# UNITED STATES PATENT AND TRADEMARK OFFICE

APPLICATION NO.	FILING DATE	FIRST NAMED INVENTOR	ATTORNEY DOCKET NO.	CONFIRMATION NO.
10/731,445	12/10/2003	Hye Yong Park	K-0589	5122
34610	7590	10/18/2005	EXAMINER	
FLESHNER & KIM, LLP P.O. BOX 221200 CHANTILLY, VA 20153			NELSON, JAMES T	
			ART UNIT	PAPER NUMBER
			3637

<b>Office Action Summary</b>	<b>Application No.</b> 10/731,445	<b>Applicant(s)</b> PARK ET AL.	
	<b>Examiner</b> James T. Nelson	<b>Art Unit</b> 3637

## DETAILED ACTION

Ford, Fig. 6

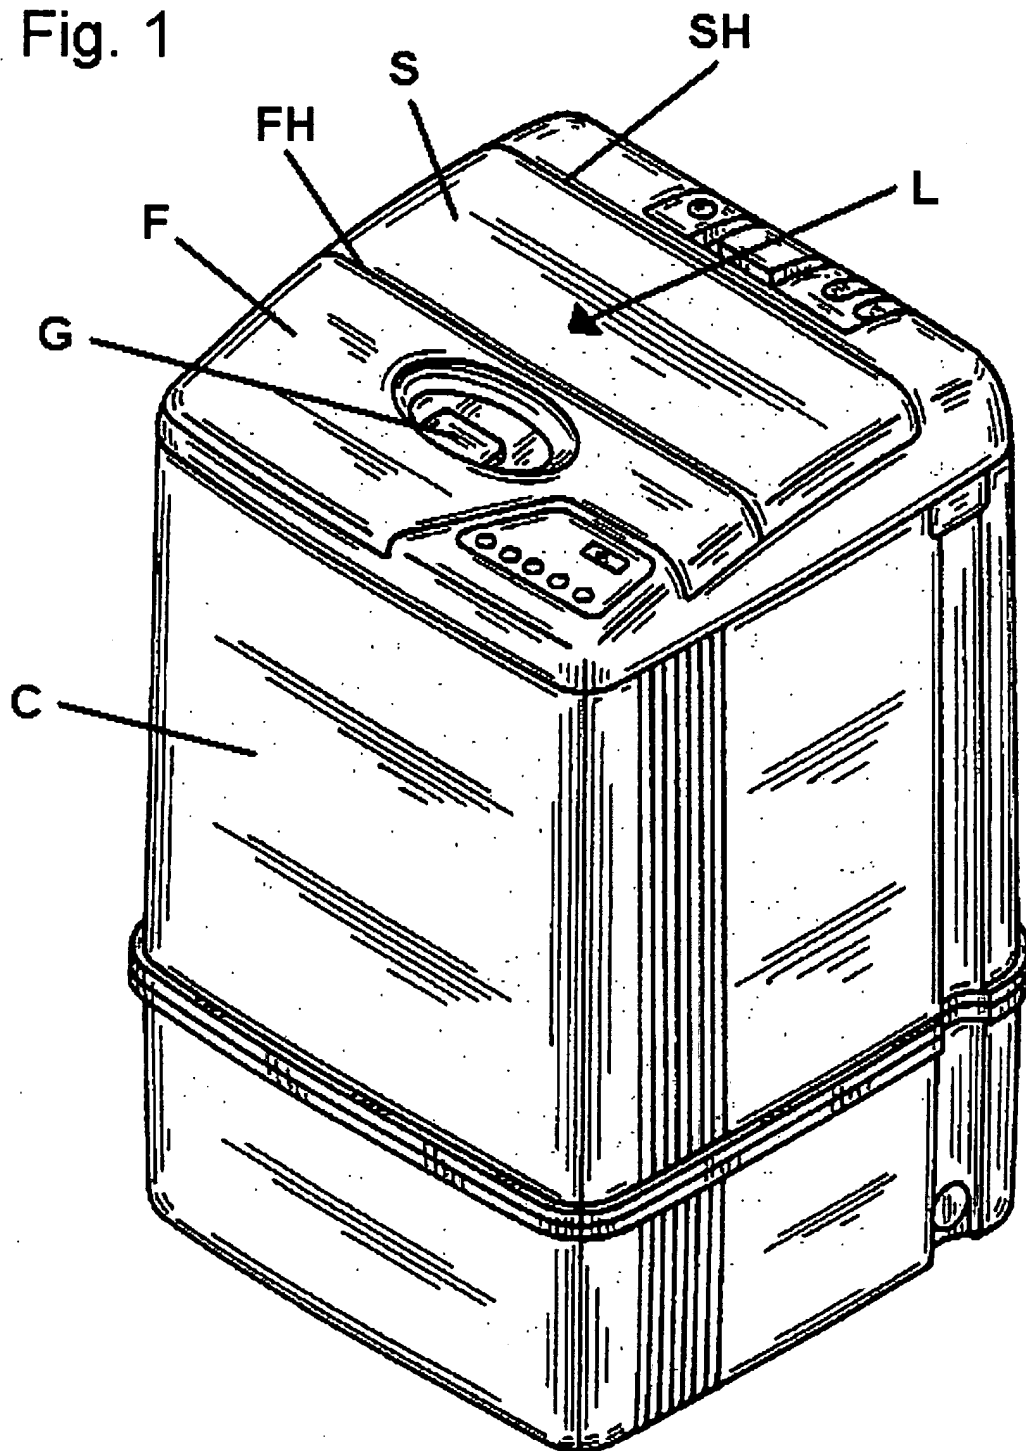
Regarding claim 1: In Fig. 6, Ford shows a cabinet comprising an outer panel (T) having at least one reinforcement rib (16), an inner panel (N) having at least one boss (30) in opposition to the at least one reinforcement rib (16) wherein the at least one boss (30) has a flat surface (D).

Regarding claim 4: In Fig. 6, Ford shows a cabinet as claimed in claim 1, wherein the at least one reinforcement rib (16) has a flat distal end surface (D) parallel to the flat surface (F) of the at least one boss (30).

Regarding claim 5: In Fig. 6, Ford shows a cabinet as claimed in claim 1, wherein the at least one boss (30) has at least one coupling groove formed (G) in the flat surface (F) in correspondence to the at least one reinforcement rib (16).

Regarding claim 6: In Fig. 6, Ford shows a cabinet as claimed in claim 5, wherein the at least one reinforcement rib (16) is inserted into the at least one coupling groove (G).

Regarding claim 7: In Fig. 6, Ford shows a cabinet for a home appliance comprising an outer panel (T) having a plurality of reinforcement ribs (16), integrally formed on an inner surface (IT) of said outer panel (T), to protrude from the inner surface to a predetermined height; and an inner panel (N) having at least one boss (30), formed on an inner surface (IN) of said inner panel (N) in opposition to the plurality of reinforcement ribs (16), wherein the at least one boss has a flat surface (F) to mate with the reinforcement ribs (16).

Regarding claim 8: In Fig. 6, Ford shows a cabinet as claimed in claim 7, wherein each of said plurality of reinforcement ribs (16) has a flat distal end (D).

Regarding claim 9: In Fig. 6, Ford shows a cabinet as claimed in claim 8, wherein the flat distal ends (D) of said plurality of reinforcement ribs (16) lie in one plane.

Regarding claim 11: In Fig. 6, Ford shows a cabinet as claimed in claim 10, wherein the reinforcement ribs (16) are respectively inserted into the coupling grooves (G).

7. Claim 3 is rejected under 35 U.S.C. 103(a) as being unpatentable over Ford (U.S. Patent 4,638,909). In Fig. 6, Ford shows a cabinet as claimed in claim 1, wherein the at least one reinforcement rib (16) is welded to the at least one boss (30). This claim is a product by process claim. The product itself does not depend on the process of making it. The product-by-process limitation "is welded to" would not impart distinctive structural characteristics to the claimed device. Welding is a common process of joining or attaching elements together. Therefore, it would have been obvious to one skilled in the art at the time of invention to modify Ford's cabinet by welding the rib and boss together to quickly and inexpensively produce the cabinet.

reinforcement rib, for joining said panels together, wherein the at least one boss has a flat surface for establishing a right angle with respect to the at least one reinforcement rib. In Fig. 6, Ford teaches an outer panel (T) having at least one reinforcement rib (16) on the inner surface (IT) of the outer panel (T), an inner panel (N) having at least one boss (30), formed on the inner surface (IN) of the inner panel (N) in opposition to the at least one reinforcement rib (16), wherein the at least one boss (30) has a flat surface (F) for mating to the at least one reinforcement rib (16). It would have been obvious to one skilled in the art at the time of invention to modify the cabinet of Sakamoto with the panel structure of Ford in order to make a more durable cabinet.

Sakamoto  
Fig. 1

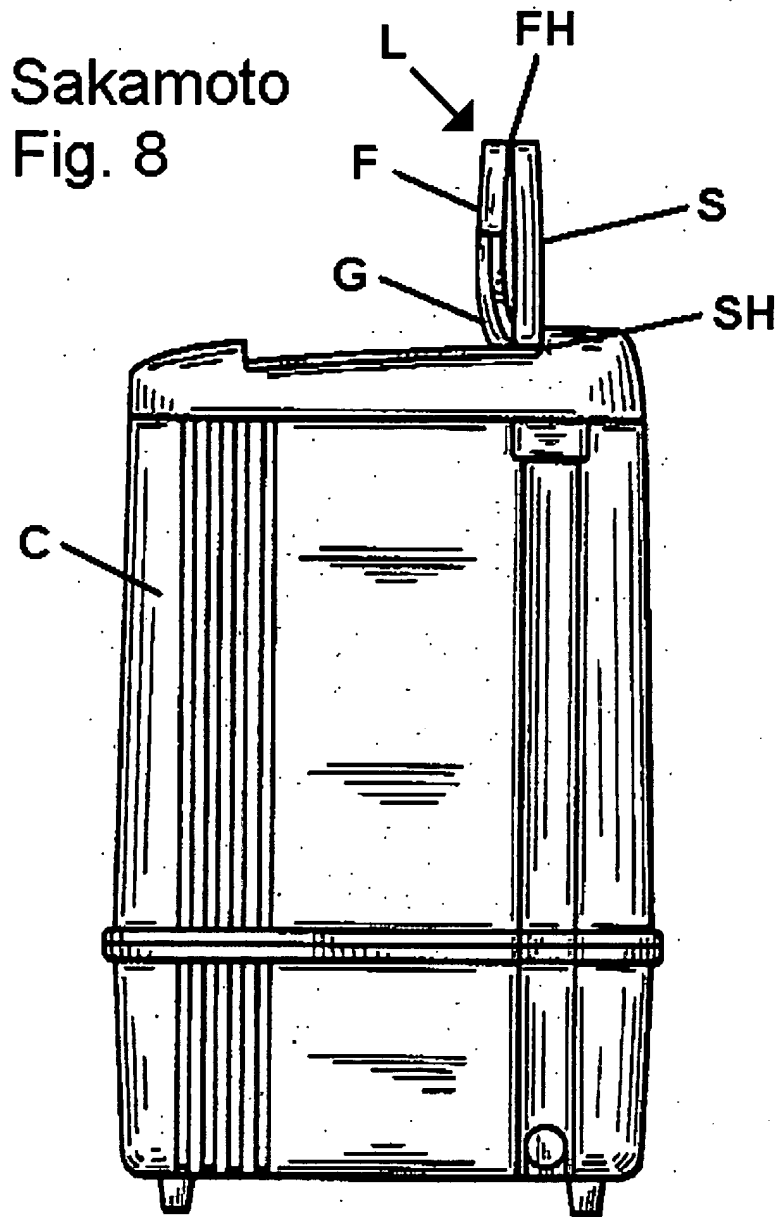
8. Claims 12-14 are rejected under 35 U.S.C. 103(a) as being unpatentable over Sakamoto (U.S. Design Patent 313,679), in view of Ford (U.S. Patent 4,638,909). In Figs. 1 and 8, Sakamoto shows a cabinet of a home appliance (C) having a sectioned lid (L) comprising a first section (F) and a second section (S) having one end hinge-coupled (FH) to the first section (F), wherein the other end of the second section (S) is hinge-coupled (SH) to the cabinet of the home appliance (C) and wherein the first section (S) comprises a grip (G). Sakamoto lacks an outer panel having at least one reinforcement rib, internally formed on an inner surface of said outer panel, to protrude from the inner surface to a predetermined height; and an inner panel having at least one boss, formed on an inner surface of said inner panel in opposition to the at least one
